UNITED STATES PATENT AND TRADEMARK OFFICE

APPLICATION NO.	FILING DATE	FIRST NAMED INVENTOR	ATTORNEY DOCKET NO.	CONFIRMATION NO.
10/672,599	09/26/2003	Kenneth Reeve	BSC-157DV	1962
30636	7590	04/05/2005	EXAMINER	
FAY KAPLUN & MARCIN, LLP 150 BROADWAY, SUITE 702 NEW YORK, NY 10038			BOGART, MICHAEL G	
			ART UNIT	PAPER NUMBER
			3761

Office Action Summary

DETAILED ACTION

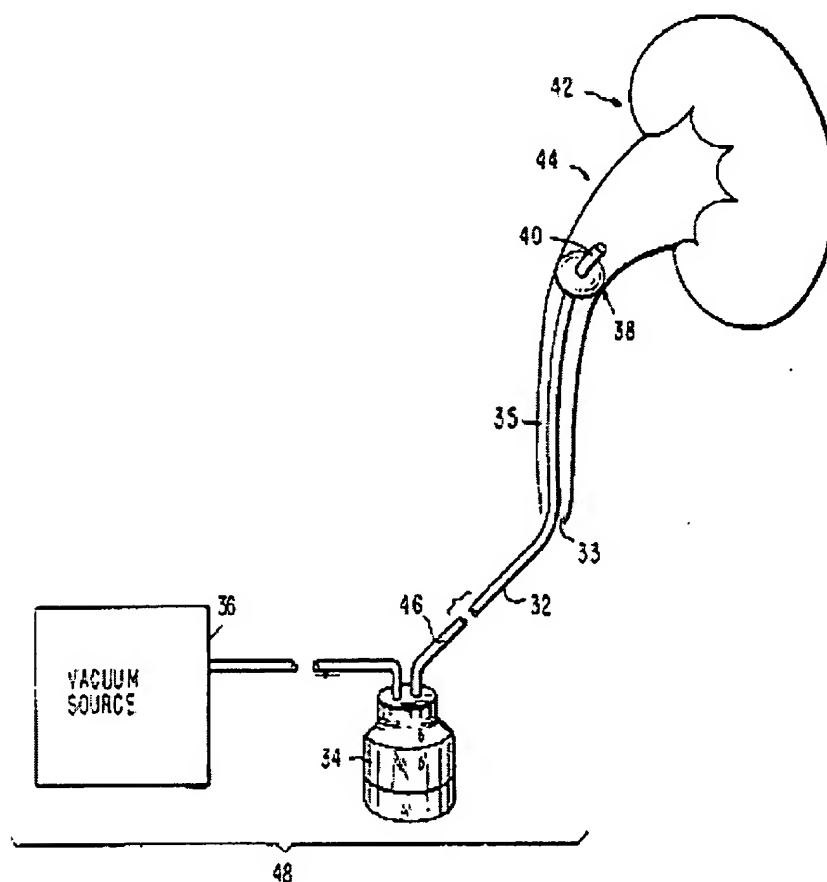
Claims 18 is rejected under 35 U.S.C. § 103(a) as being unpatentable over Ikeguchi (US 6,500,158 B1).

Ikeguchi teaches a first catheter (32) positionable in a patient's first ureter (35), the first catheter (32) having a proximal and a distal end (40, 46), the proximal end (40) of the catheter (32) including a ureter to catheter seal (38), the distal end (46) of the catheter capable of passing through the patient's urinary sphincter, the distal end (46) of the catheter capable of being connected to an external urine collector (34)(see fig. 2, below).

Ikeguchi expressly discloses the claimed invention except for there being two catheters, one for each ureter of a patient.

In the present case, it would have been obvious to one of ordinary skill in the art to modify the system of Ikeguchi to include two catheters in order to provide for patients who need simultaneous treatment of both ureters.
